Staff Report

Knoxville Historic Zoning Commission

File Number: 12-J-25-HZ

Location: 22 Market Sq. **Parcel ID:** 94 L E 038

HZC 2.1

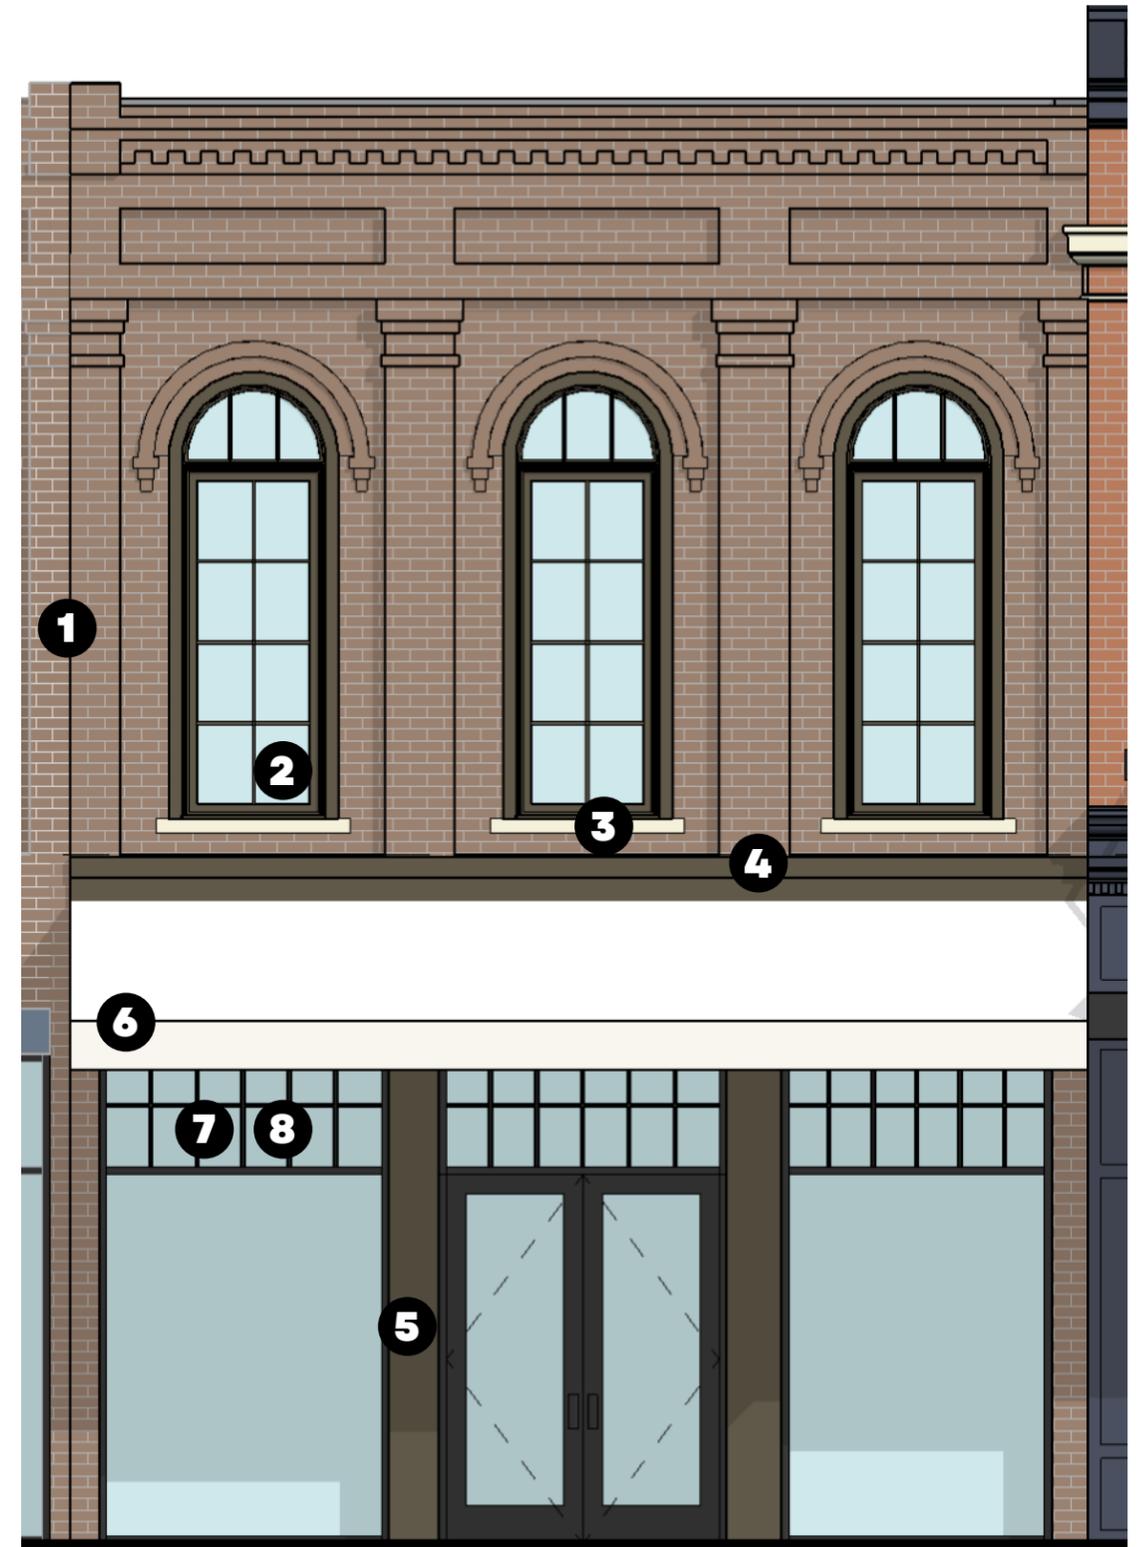
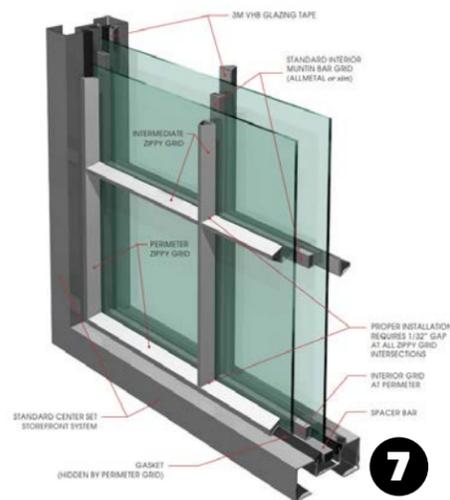
2. The exterior rehabilitation scopes at 22 Market Square are all basic repair scopes which meet the design guidelines.
 3. The exterior rehabilitation scopes at 18 Market Square are largely repair scopes which meet the design guidelines. The application proposes to reconstruct an upper cornice to reflect historic photographs, which is specifically called out in the design guidelines. Guidelines recommend cornices of wood, sheet metal, or other materials that duplicate the appearance of the original. The project will also include the installation of trim to the flat green wrap on the ground-level piers.

6. Sloped canvas awnings are proposed for 22 and 16 Market Square. The proposed placement of the awnings is appropriate. The design guidelines recommend that awnings project four to seven feet from the building, while the proposed awnings will project ten feet from the building. Larger awnings have been approved by the HZC on a case-by-case basis. The awnings are compatible in scale with adjacent awnings, and do not detract from the overall character of the building; the increased size is appropriate for both 22 and 16 Market Square. The overall visual massing of the two awnings and the canopy will be broken up between the three buildings.

Staff recommends approval of Certificate 12-J-25-HZ, subject to the following conditions: 1) all masonry repair and repointing to meet specifications of NPS Preservation Brief 2; 2) final window replacement specifications to be submitted to staff for approval.

HZC 3.1

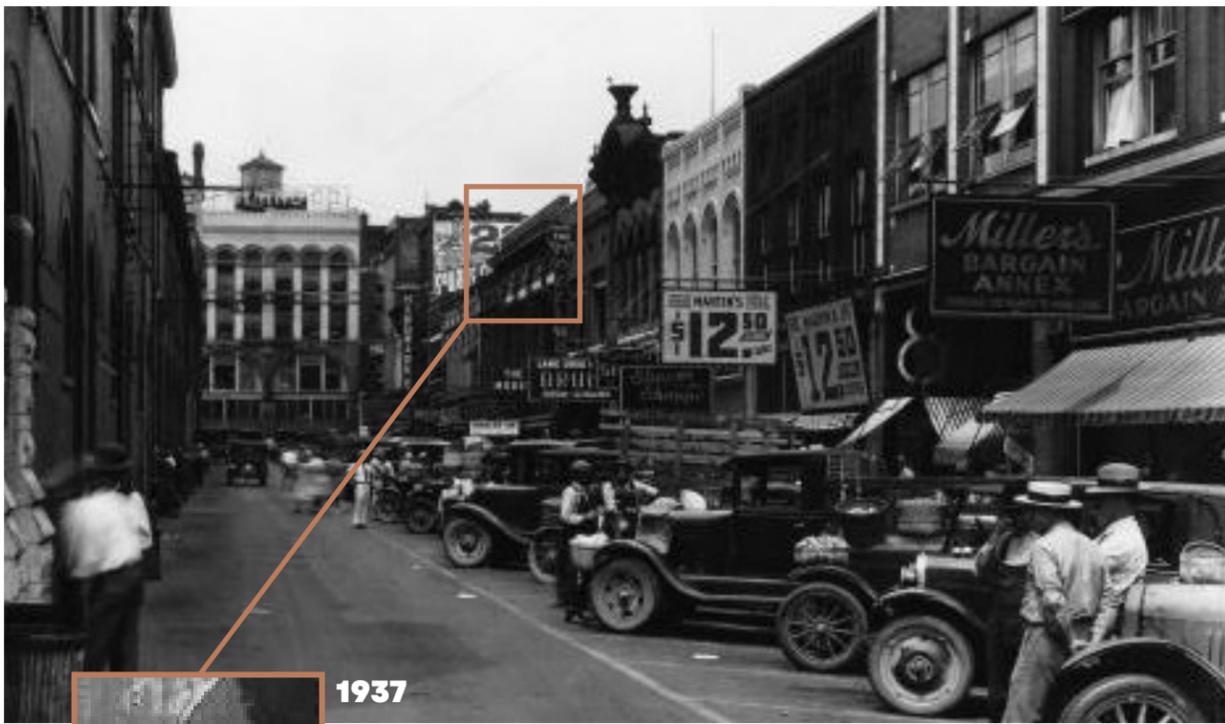
7. The Market Square design guidelines do not specifically address canopies, but make recommendations for awnings. Guidelines for awnings recommend that they are placed above the display windows and below the storefront cornice or sign panel and reinforce the frame of the storefront without covering sills, cornice, or piers. Following these guidelines, placement of the canopy at 18 Market Square is appropriate.

- Flat metal canopies have been approved in Market Square on a case-by-case basis, including at 2 Market Square (5-D-19-HZ) and 15 Market Square (May 2014). Flat metal canopies have been approved if they are placed according to the guidelines, proportionate to the storefront, do not alter historic features or materials of the building, and

could be removed without significant effect to the storefront. The proposed metal canopy at 18 Market Square meets these standards. The canopy features only three metal tiebacks connecting to the masonry, which further reduces the overall visual impact.

FLOOR PLAN - 1" = 10'

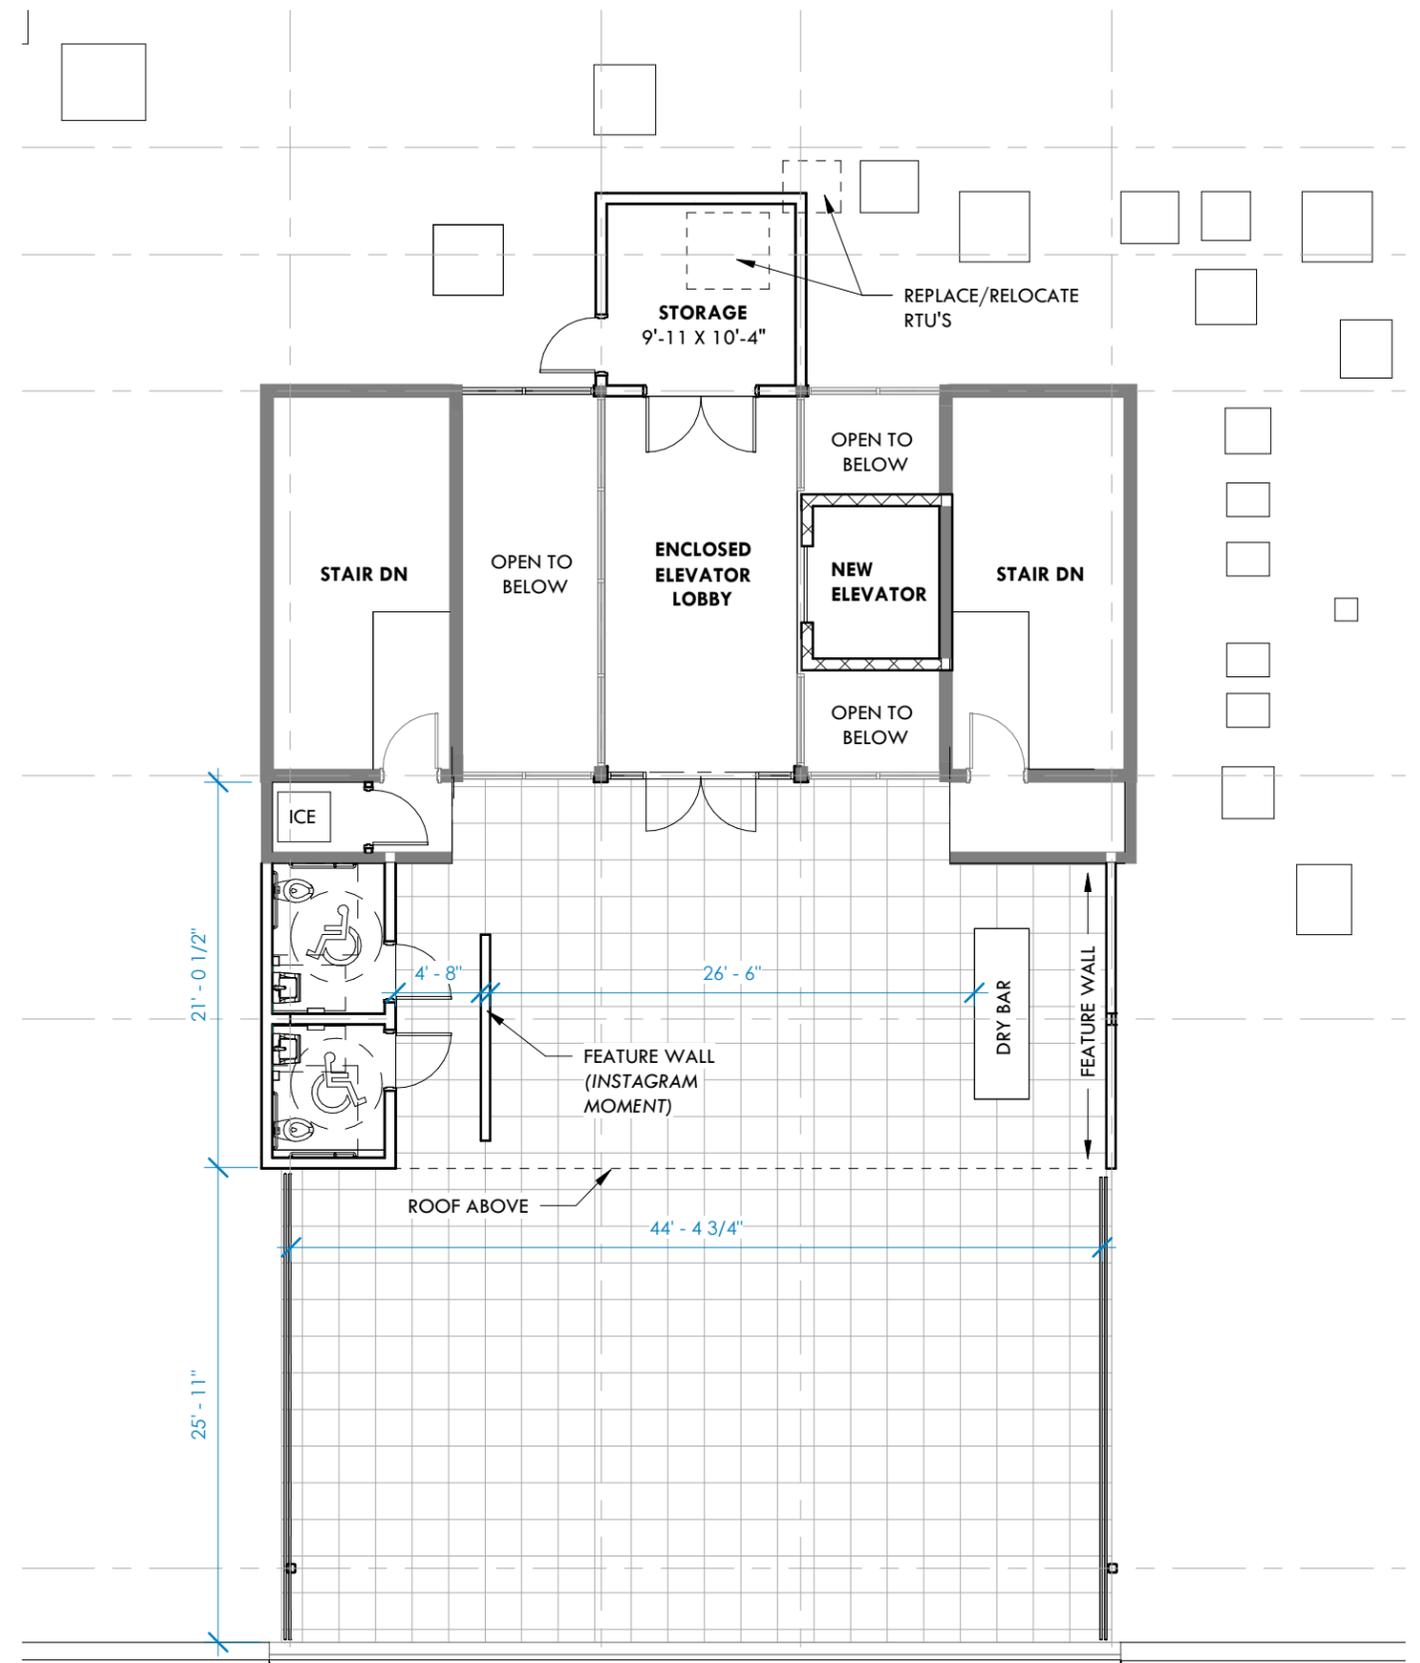
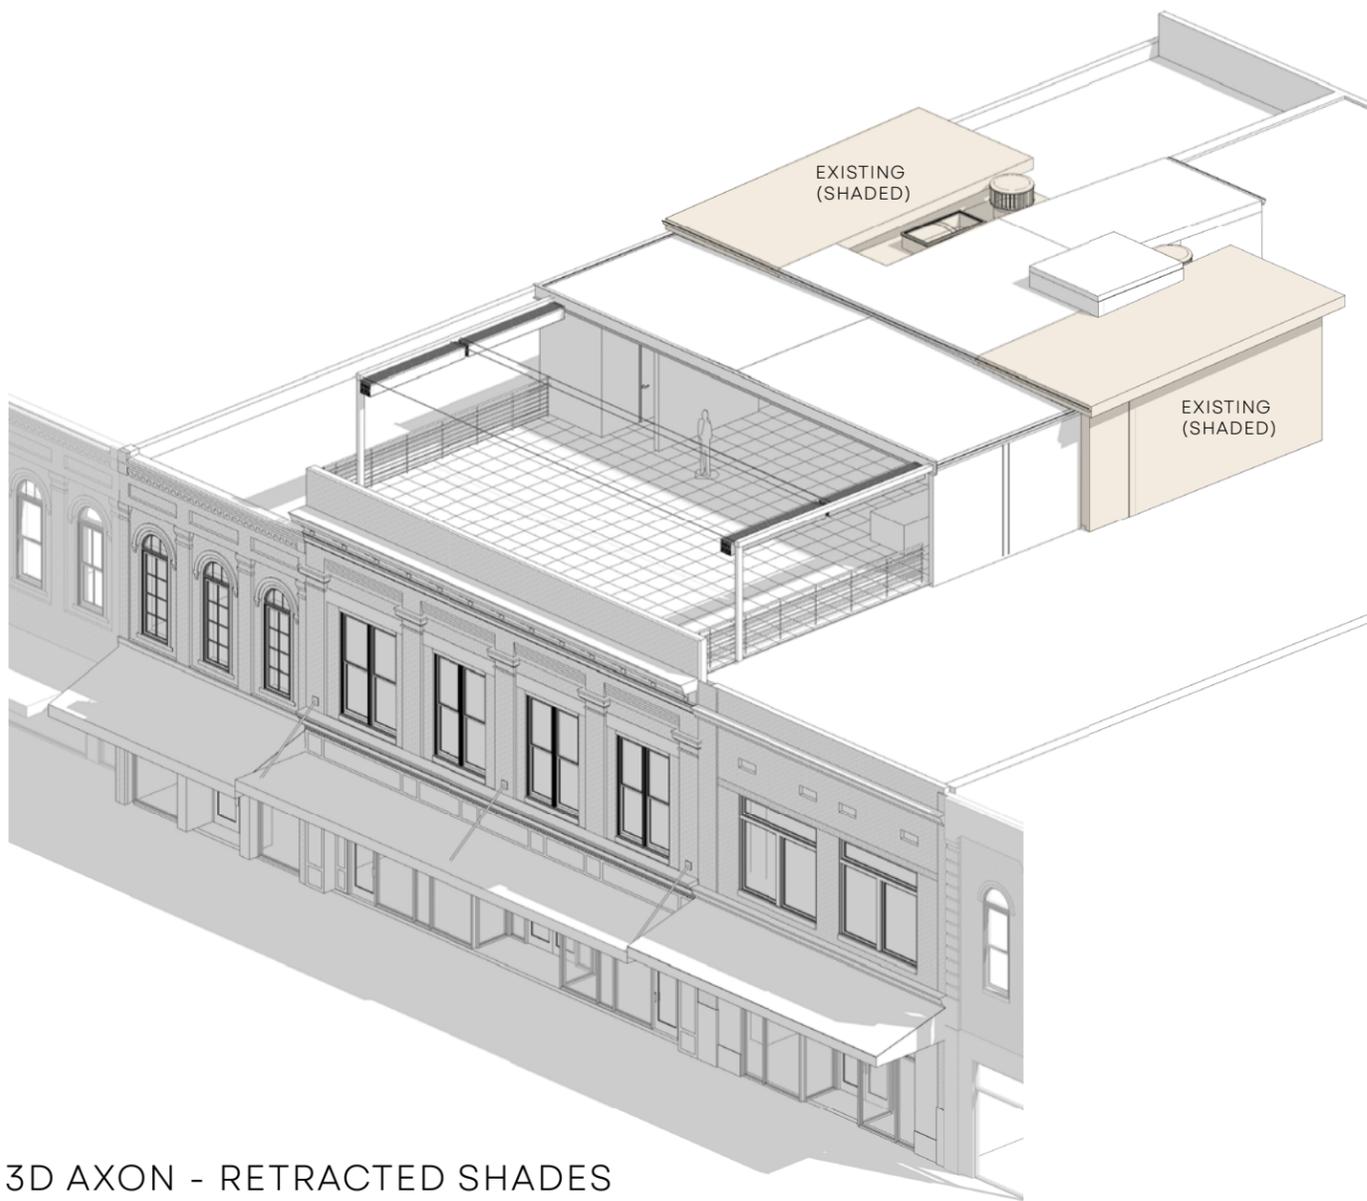
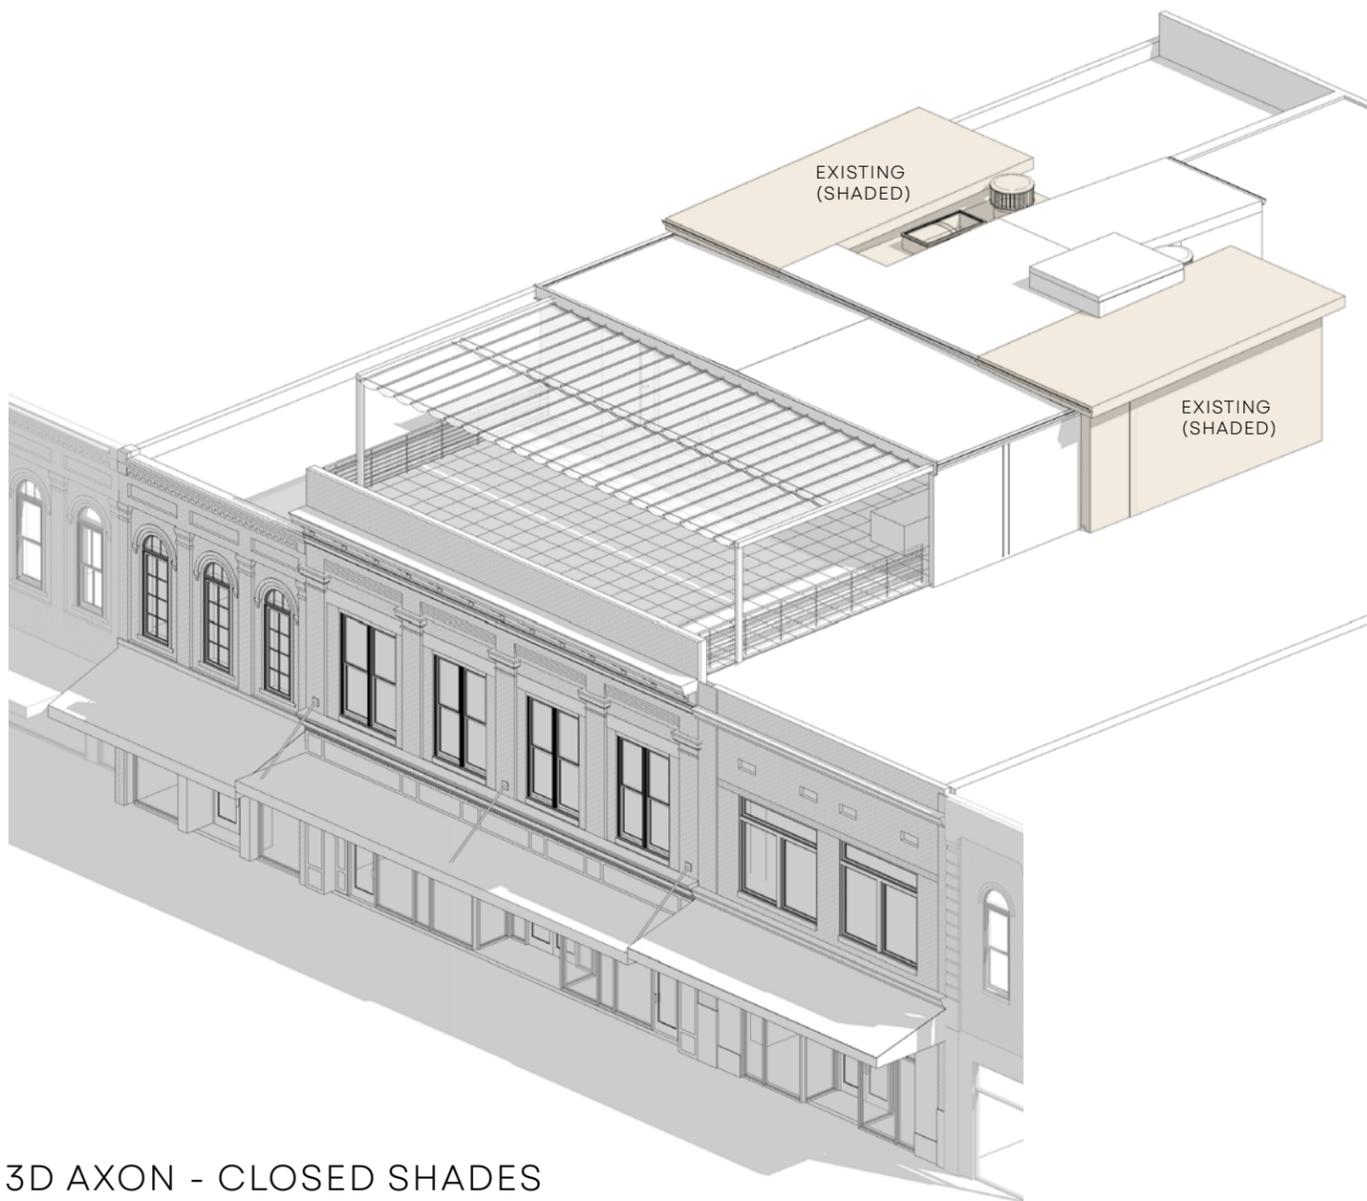
8. The proposed roof work at 18 Market Square will expand an existing rooftop addition. Rooftop additions in Market Square are typically evaluated by visibility from the street. An additional 21'-0.5" deep bathroom space will extend from the left side of the rooftop massing, with a similarly sized feature wall on the right side, and a flat roof connecting the two. The bathroom addition will not be visible from the ground level in Market Square and is small in scale compared to the existing addition. The elevator addition will occur within the existing addition massing.

9. A wood-look support with a retractable sunshade will project 25'-11" towards the building's façade. The support and sunshade, when closed, will be visible from the ground level. Other permanent sunshades are visible from the ground level in Market Square, though most were installed without permits or HZC review. The sunshade and support could easily be removed without effect on the historic building. The HZC should discuss the visibility of the support structure and sunshade.
